### RAPIDPoint® 500 System

#### Dual LIS Port Invalid Result Transmission

#### Reason for the Urgent Field Safety Notice

**Figure 1. Serial Port Configuration Screen Showing Enabled and Disabled States of the Port**

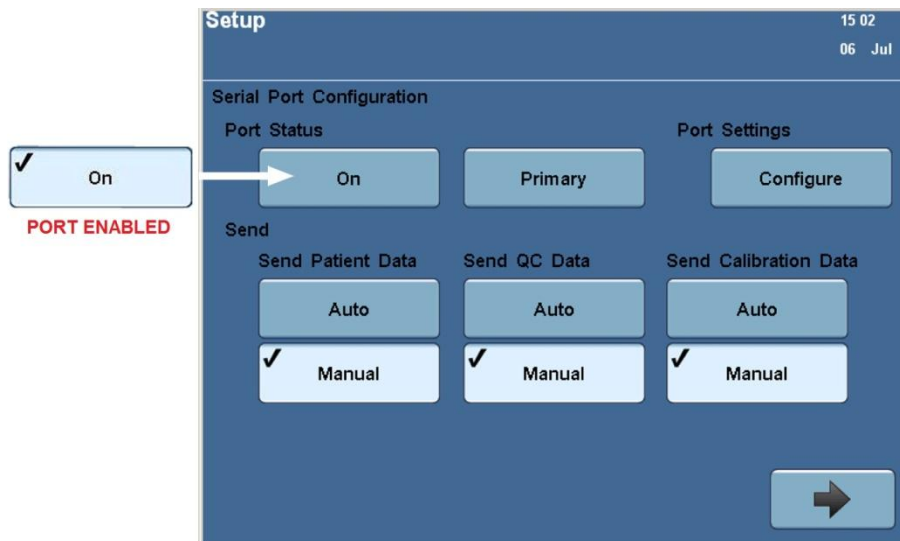
If the system is currently set up with dual LIS transmission enabled, one of the ports (either Serial or Ethernet) needs to be disabled.

**To Disable the Serial Port Connection:**

1. At the **System** screen, select **Setup**. Enter your password if required.
2. Select **Printer and Devices > Communications > LIS Communications**.
3. Select **Configure** in the **Serial** column.
4. Select **Port Status > On** to disable the Serial port.  
The port is disabled when the button is blue and there is no checkmark.
